# BLDG VI NORTH COURTYARD ELEVATION

# ATLANTIC CROSSING

Project Number: 217093

**A6.5**

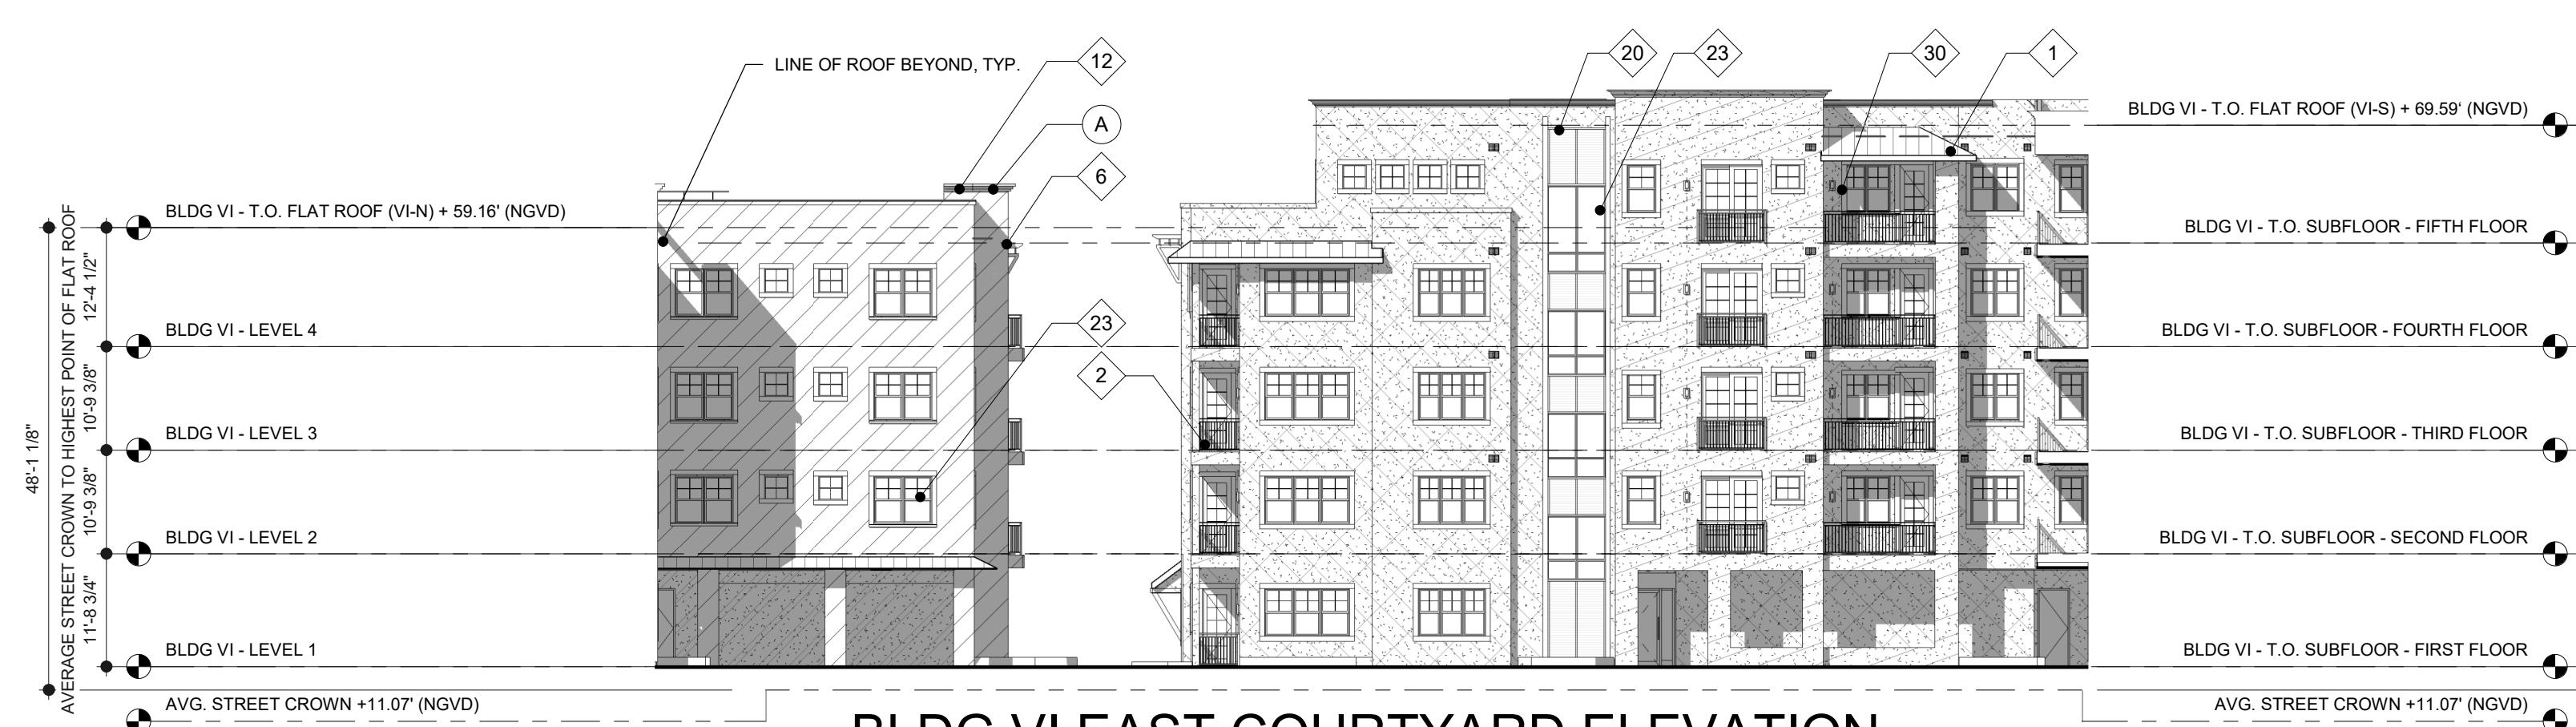
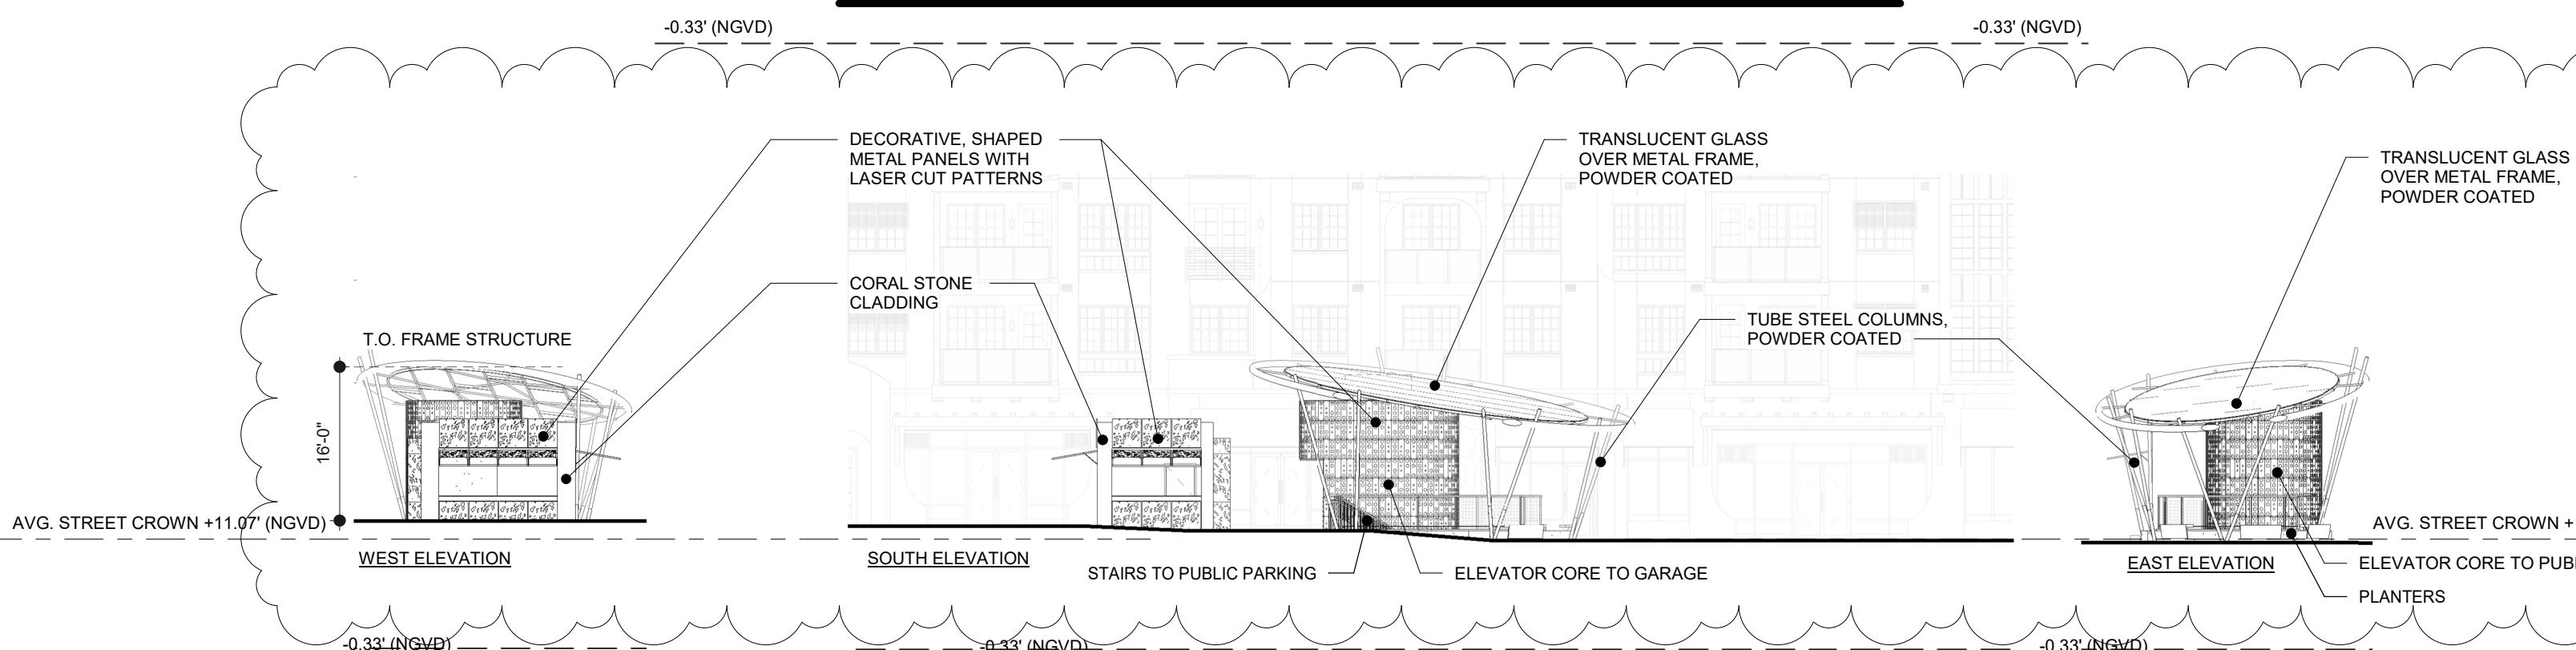
• LIGHT TRANSMISSION FOR GROUND FLOOR GLASS AREA TO BE NO GREATER THAN 20%			12	Stucco parapet (6'-0 high max. from top of roof deck)
• PROVIDED ELEVATIONS OF THE SCREENING DOORS AT TRANSFORMER ENCLOSURES			13	Stucco with simulated stone texture base
<u>ARCHITECTURAL ELEVATION REVISIONS 7.19.2018</u> GENERALLY REVISE ELEVATIONS TO BE MORE CONSISTENT WITH MASONRY MODERN, INCLUDING:			14	Overhead garage door - Glass

• STRENGTHENING PEDESTRIAN SCALE OF ENTRY TO LEASING (NORTHWEST CORNER)			15	Decorative arched louver panel; powder coated
• ENHANCED HORIZONTAL DETAILING AT BASE - ADDED ROOF FORMS, CONSOLIDATED COLOR, MINIMIZED TALL SLENDER VERTICAL FORMS			16	Wood boxed out detail

• ENHANCE DETAILING AT BUILDING CAP			17	"Living wall" - Plant material over stainless steel support Considered a trellis and will be allowed within setback

• ENHANCE DETAILING AT BUILDING CORNERS			18	Perforated metal panel railing
<u>CLASS II MODIFICATION 8.2.2019</u>			19	Wood panel railing
• ADD TRELLIS BETWEEN III & VI-S			20	Paneled wood accent

• REVISE DETAIL AT ELEVATOR/STAIR/BAR FEATURE BETWEEN I & III			21	Louvered panels; powder coated
			22	Steel Trellis
			23	Vinyl windows
			24	Decorative wood brackets
			25	2" Reveal
			26	Decorative stucco inset
			27	Steel Cable Railing
			28	Fluted column cap; stucco
			29	Ornamental iron gates and screen; powder coated
			30	Exterior light fixtures
